Staff Report: Site Plan Amendment 81990069B, Montgomery Industrial Park, Lot 32

APPLICATION DESCRIPTION:

MCPB No. 10-107
Site Plan No. 81990069B
Project Name: Montgomery Industrial Park, Lot 32
Hearing Date: July 29, 2010

Illustrative Comparison (Amendment B)

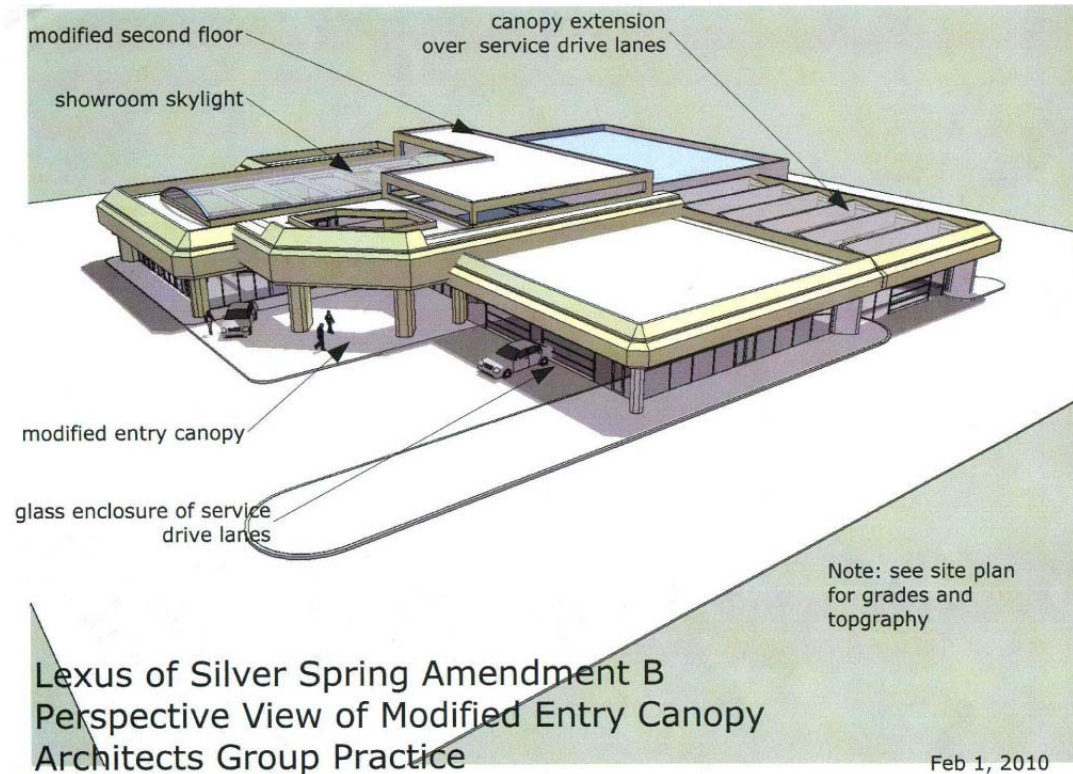
In addition to the internal building modifications, the external configuration will also be altered. A skylight will be longitudinally placed over the showroom of the first floor on the northern side of the main building. The second floor will be modified to include another skylight; and the building canopy will be expanded by 2,022 square feet. The existing building canopies and the new expansion will be enclosed with glass; and the entrance canopy will be modified to incorporate an open hexagonal shape connecting the showroom and service driveway canopy. Ultimately there is no net increase to the approved building square footage; however the building coverage will be increased by 3,736 square feet.

SITE PLAN AMENDMENT - MNCPPC FILE NO. 81990069B

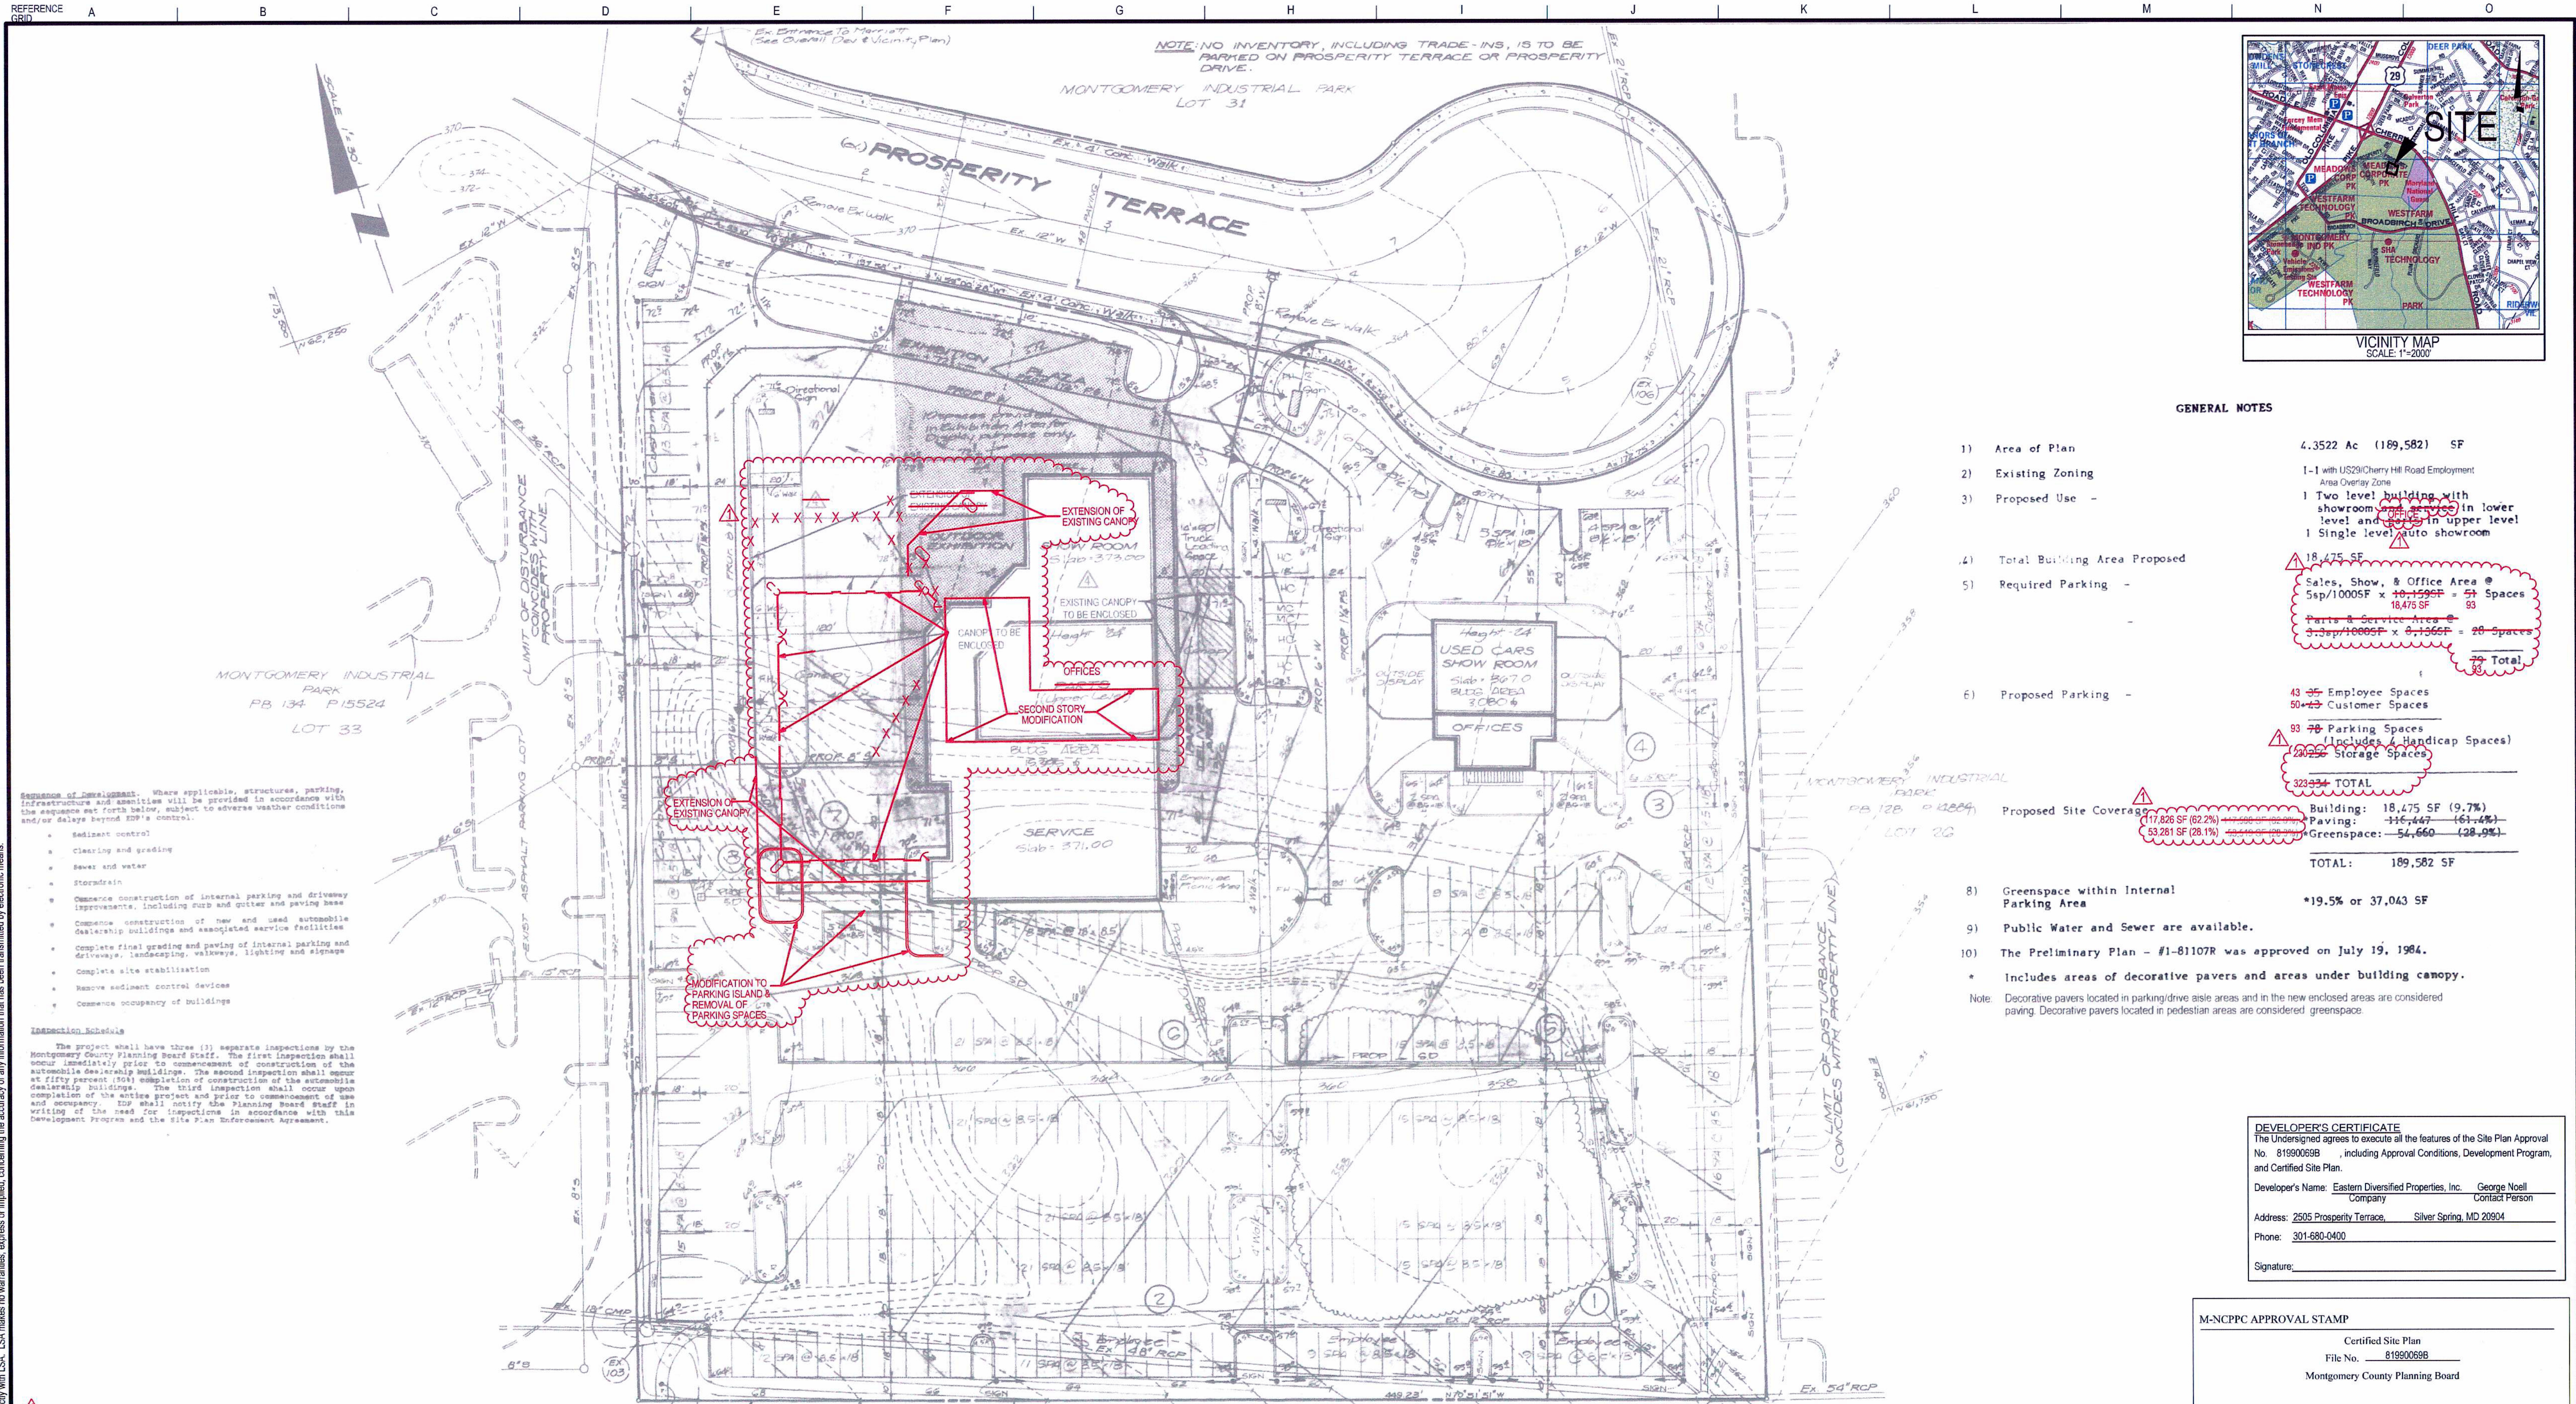
CONSENT AGENDA AMENDMENT LIST OF CHANGES FOR SITE PLAN AMENDMENT "B"

1. RECONFIGURE BUILDING AREA FOR ENTRY, SERVICE, AND SECOND FLOOR
2. ELIMINATE PARKING BY SERVICE
3. MODIFY SIGNAGE
- * EXPANSION OF WESTERN CANOPY TO THE SOUTH
